ADDENDUM NO. 2

**Hamilton County Department of Education
Dalewood Middle School Re-Roofing (Phase 1)
Derthick Henley & Wilkerson Architects**

**Date: January 19, 2023
HCDE Bid No. 23-15
DHW Project No. 82211-B**

A7 Typical Roof Assemblies
A100 1:12" = 1'-0"

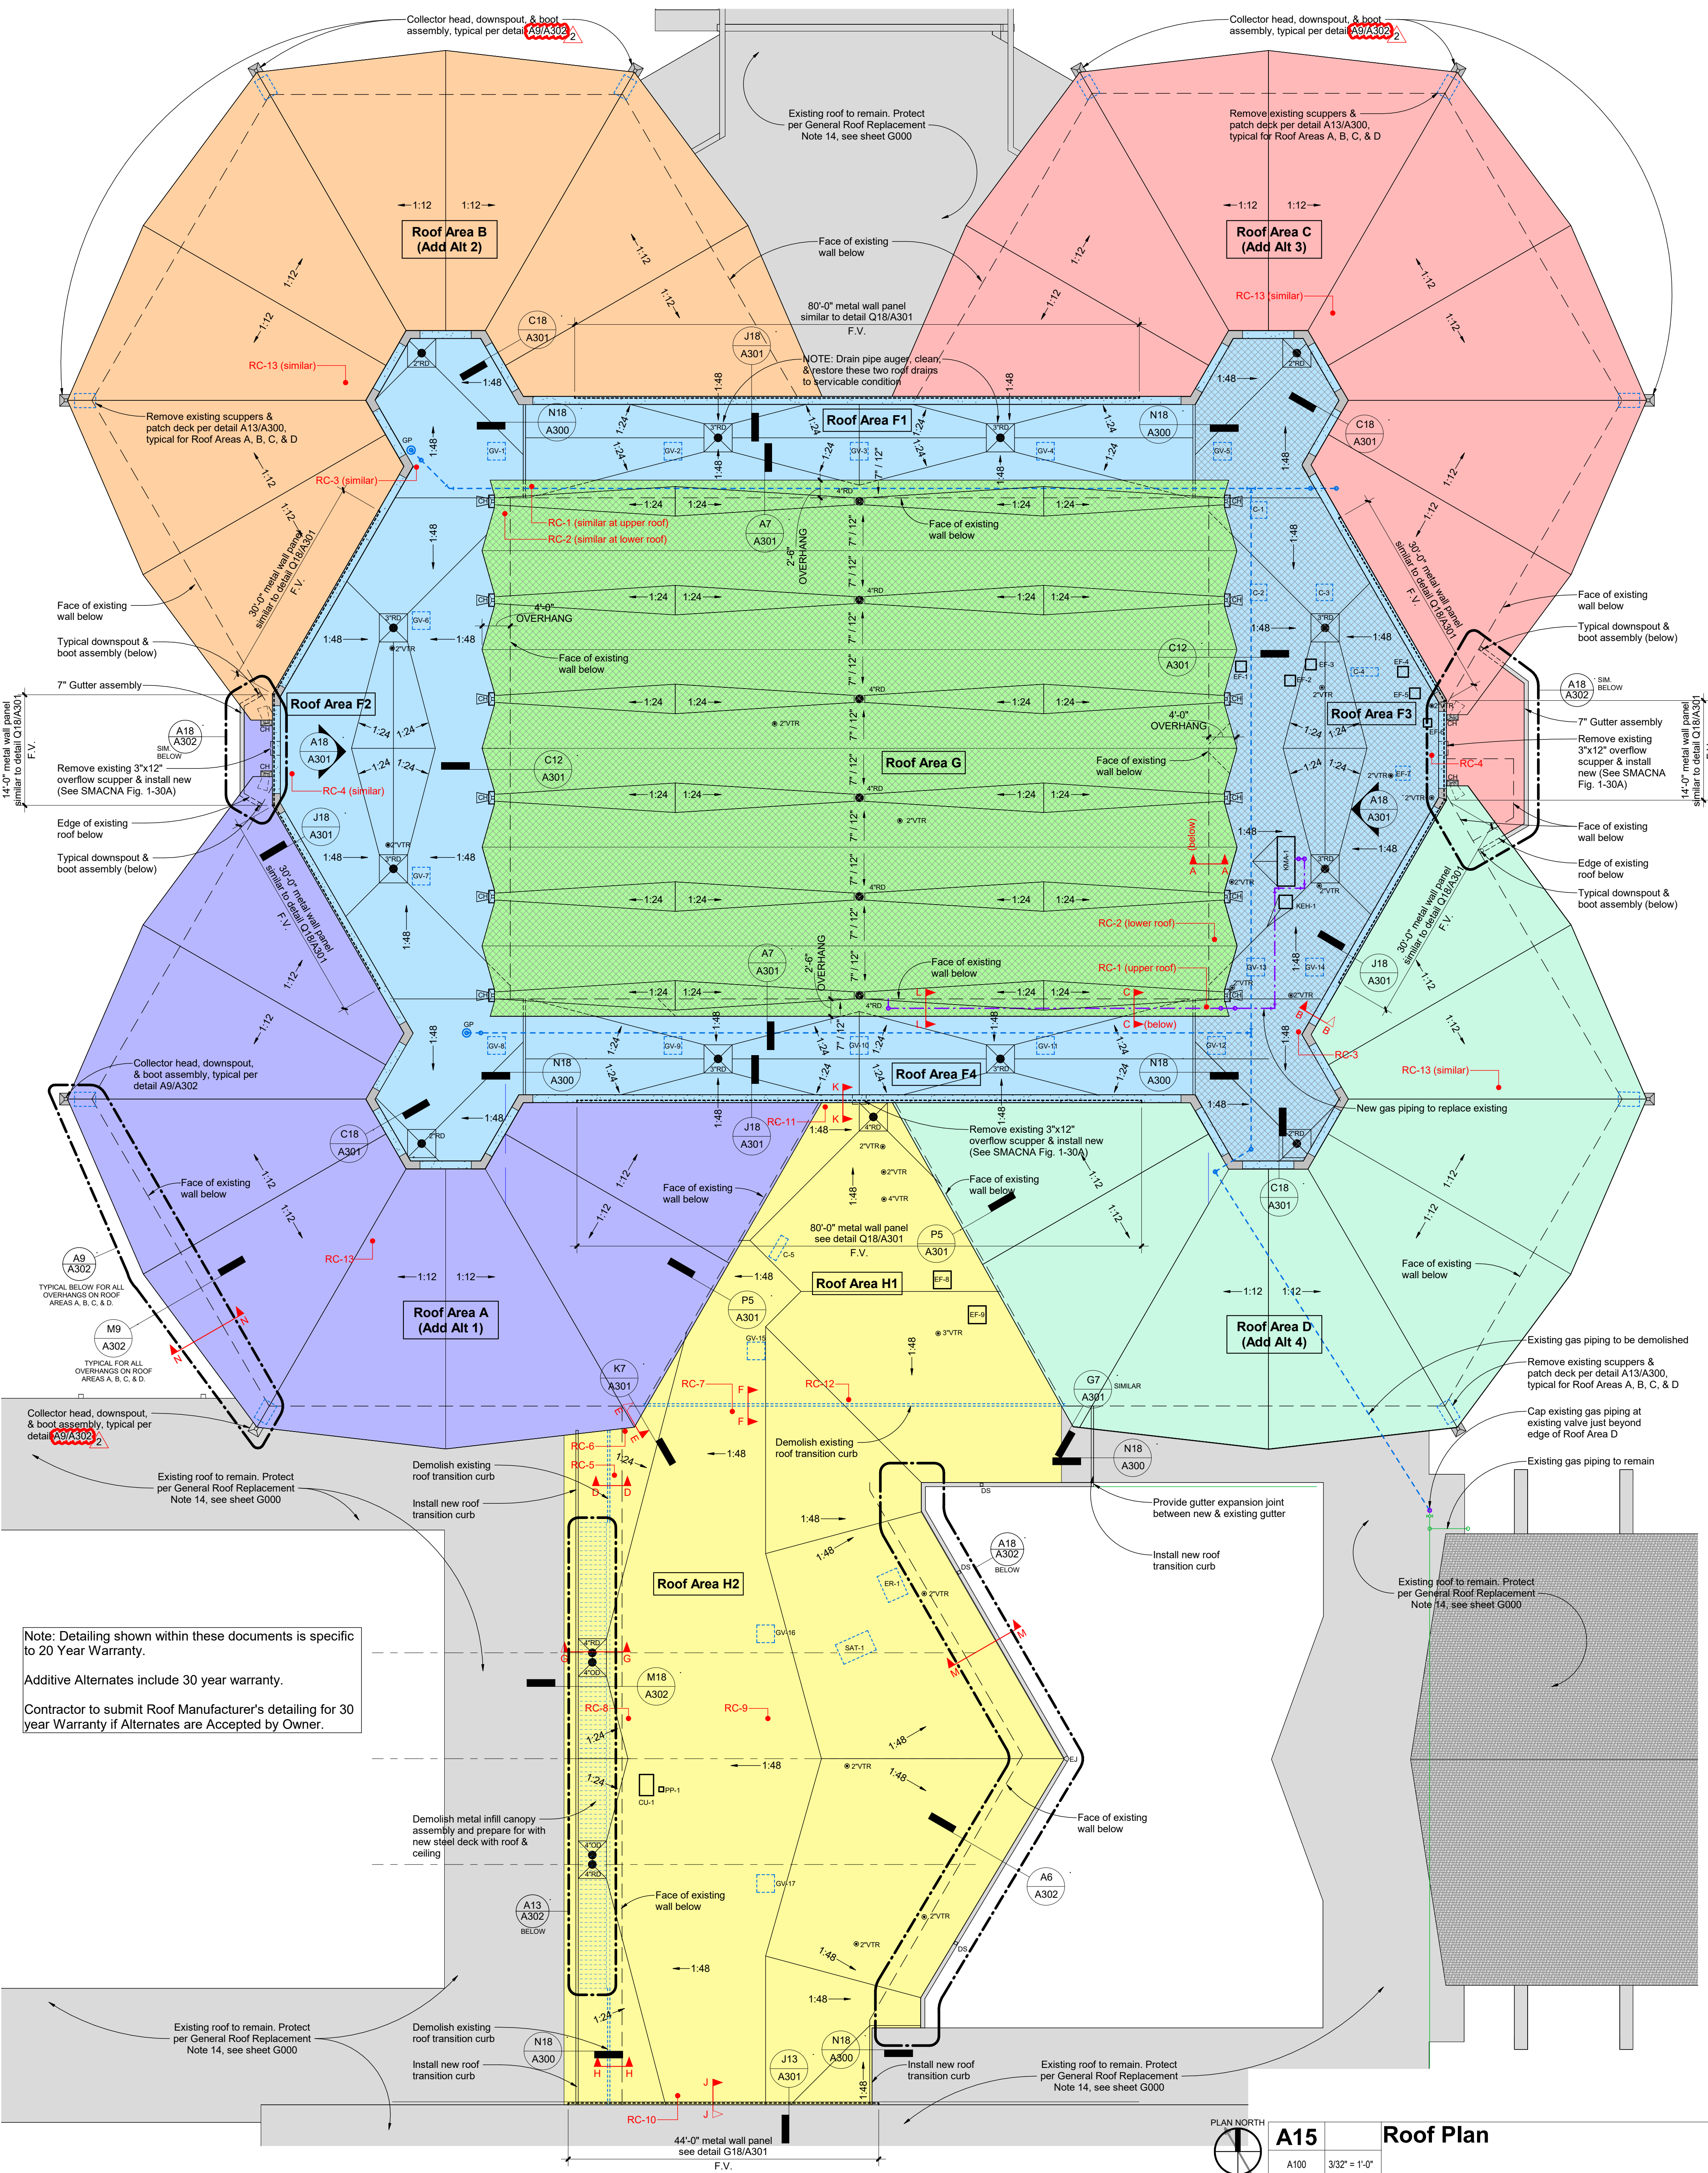
- Delete all references to 'Torch Applied' from detail A7/A100.
- Replace all references to detail 'A9/A304' with detail 'A9/A302'.
- Sheet with clouded revisions is attached to this Addendum.
